# UNITED STATES PATENT AND TRADEMARK OFFICE

**Office Action Summary**

10/574,425

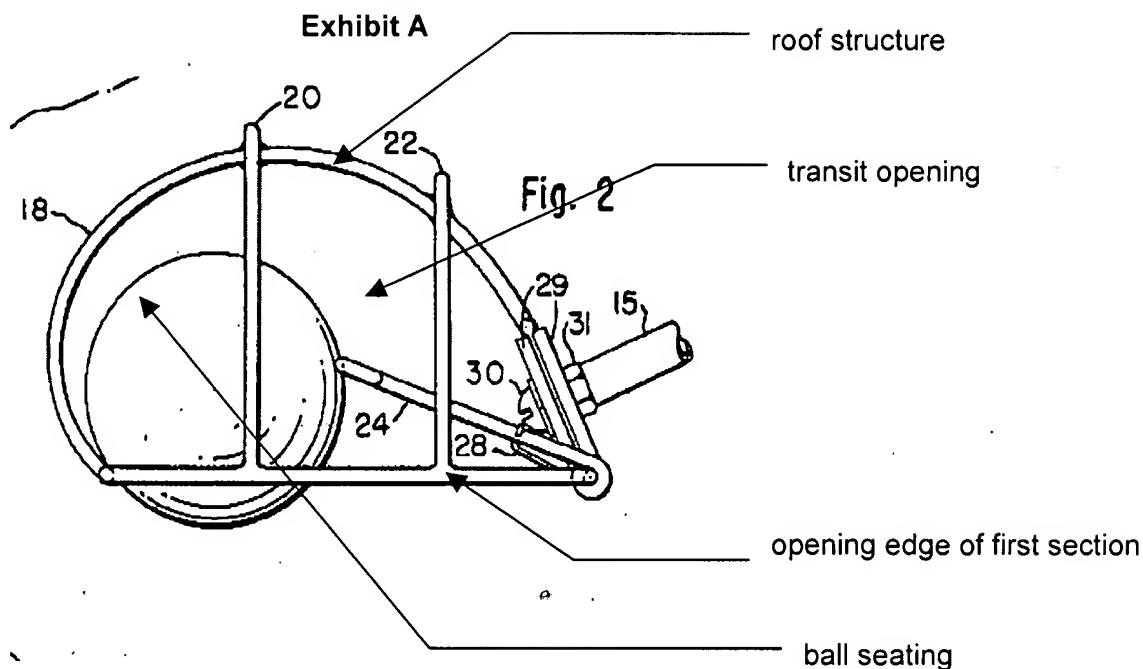
Christle (3,046,044) discloses a golf ball retrieval device comprising an elongated handle 12, a cage (Fig. 2), having a first section and a second section, the first section having an opening edge (see Exhibit A), a transit opening which connects the first section and the second section and which forms a threshold over which the ball go through, the second section having a downwardly open opening forming a ball seating, and a roof structure.

Re claim 2, Exhibit A shows the threshold in combination with a member 24 capable of preventing the ball from rolling from the ball seating.
